Access Compliance Report

Public Rights-of-Way

(Curb Ramps)

Intersection ID: 23944	Main Street: BOSHAM_LN	Cross Street: PRESCOTT_POND_LN	Location: W
ADA ID: 5B00C433803F	Ramp Type: Perp	Initial Pass/Fail: Fail	Overall Compliance: No
		Severity Score: 8.75

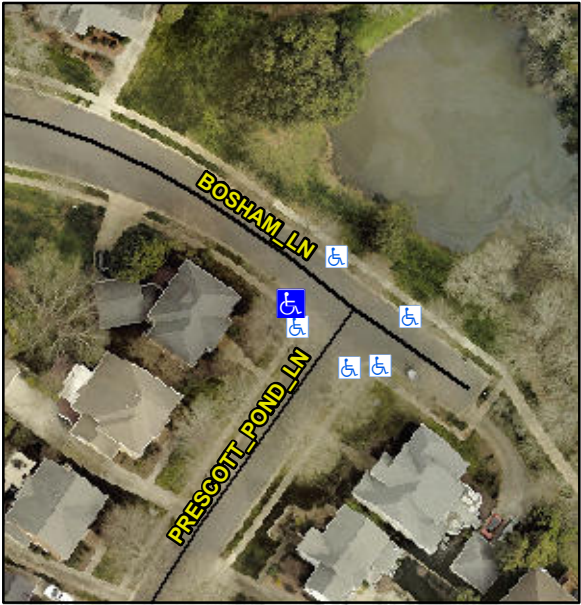
Codes/Mitigation Info/Possible Solution			Field Measurements/Component Compliance		
	Possible Solutions:		Compliance	Description	Data
	Remove & Replace Entire Ramp.		Yes	Ramp Length (in)	48.0
			No	Ramp Width (in)	47.5
			N/A	Flare Type LT	N/A
			N/A	Flare Slope LT (%)	N/A
			N/A	Flare Traversable LT?	N/A
			N/A	Landing Length (in)	N/A
			N/A	Landing Width (in)	N/A
			N/A	Landing Slope (%)	N/A
			N/A	Landing X Slope (%)	N/A
<p>Surveyor Notes:</p> <p>N/A</p> <p>PROW/ADA:</p> <p>R304.5.1</p>			N/A	Flare Type RT	N/A
			N/A	Flare Slope RT (%)	N/A
			N/A	Flare Traversable RT?	N/A
			N/A	DWS Provided?	N/A
			N/A	DWS Contrast?	N/A
			N/A	DWS Length (in)	N/A
			N/A	DWS Full Width?	N/A
			N/A	DWS Offset (in)	N/A
			N/A	Shared Landing?	N/A
			N/A	Gutter Ponding?	N/A
			N/A	Gutter Lip Ht (in)	N/A
			N/A	Painted X Walk1?	No
				X Walk 1 Direction	To NE
			N/A	X Walk 1 Width (in)	N/A
				X Walk 1 Slope (%)	1.5
				X Walk 1 X Slope (%)	0.7

N/A	Ramp inside XWalk1?	N/A
			N/A	Road Slope (%)	N/A
			N/A	Road X Slope (%)	N/A
			N/A	Any Obstructions?	N/A
				Obstruction Type	
			N/A		
			N/A		
			N/A		
			N/A		
			N/A		
			N/A		
			N/A		
			N/A		
			N/A		
Total Cost:		\$ 1850.00			
			N/A		
			Yes	Surface Condition? (G/P)	Good
